# UNITED STATES PATENT AND TRADEMARK OFFICE

10/521,399

<b>Office Action Summary</b>	Application No. 10/521,399	Applicant(s) ORSCHULIK, GUNTER	
	Examiner Kristen C. Hayes	Art Unit 3643

## **DETAILED ACTION**

**Modified Figure 3, US Patent 3,949,524**

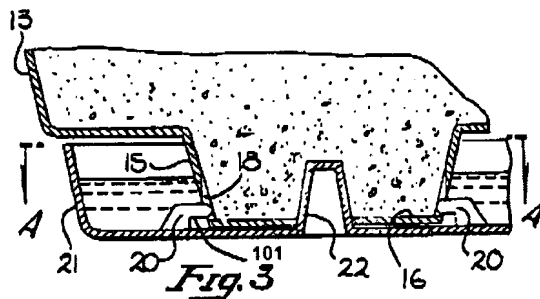
10. Regarding claim 1, Mickelson discloses a plant container comprising a pot (11) and a coaster (21), whereby the coaster which is closed at the bottom and serves as a water dish (Mickelson, column 3: lines 16-17) is to be undetachably attached (Mickelson, column 1: lines 59-62) by coupling elements (18, 20) to the pot which is provided with holes (18) on the bottom, wherein the coaster and the pot are mutually

engaged via at least one guide surface (22) tapering in a conical shape and they become engaged with one another by means of the coupling elements via a rotational movement (Mickelson, column 3: lines 6-9). Mickelson does not disclose the device being made of plastic. However, it is well known to those in the art to use plastic as a material for planters. The device being made of plastic would allow the pot and coaster to easily engage each other by allow the coupling elements to elastically deform. Additionally, the examiner also notes that it has been held to be within the general skill of a worker in the art to select a known material on the basis of its suitability for the intended use as a matter of obvious design choice. *In re Leshin*, 125 USPQ 416.

11. Regarding claim 2, Mickelson discloses a device with the limitations of claim 1 further characterized by the guide face (22) is designed on a central dome in the form of a truncated cone.

12. Regarding claim 17, Mickelson discloses a device with the limitations of claim 1 further characterized by the coupling elements (20) are designed in the form of hooks on the coaster and holes (18) in the wall of the pot.

13. Regarding claim 18, Mickelson discloses a device with the limitations of claim 1 wherein the coupling elements are secured by catch elements (Mickelson, column 3: lines 36-39).

**Modified Figure 1, EP 0 842 599**

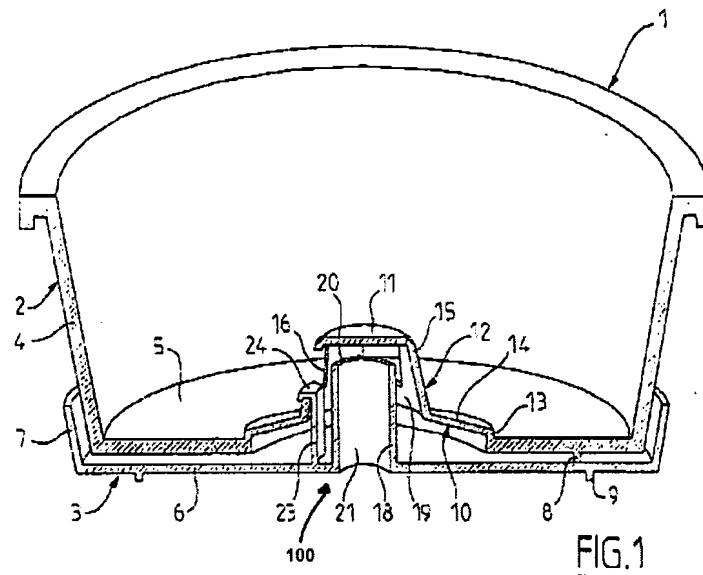
15. Regarding claim 3, Mickelson discloses a device with the limitations of claim 2 but does not disclose the dome being provided with the coupling elements. However, Grigi teaches a dome (21) provided with coupling elements (23). The coupling elements being on the dome would allow for alignment of the coaster with respect to the pot. The location of the coupling elements would simplify the mating of the elements. If the coupling elements were in different locations throughout the device they would be more difficult to align and would complicate the device. Therefore, it would have been obvious to one of ordinary skill in the art at the time of the invention to modify the position of the coupling elements of Mickelson with the position of the coupling elements of Grigi in order to simplify the mating of the elements.

coaster (3) being designed with a dome in the shape of a truncated cone with the pot and the coaster having abutting guide faces (Grigi, Figure: 1). The pot and coaster both being designed with a dome would allow the domes to be concentrically aligned. The concentric fit of the domes would aid in providing a secure connection between the pot and the coaster. Also, this alignment would ensure that the coaster was directly under the pot, which would aid it in catching water draining from the pot. Therefore, it would have been obvious to one of ordinary skill in the art at the time of the invention to modify the pot of Mickelson with the dome of Grigi to provide a secure, concentric fit between the pot and coaster.
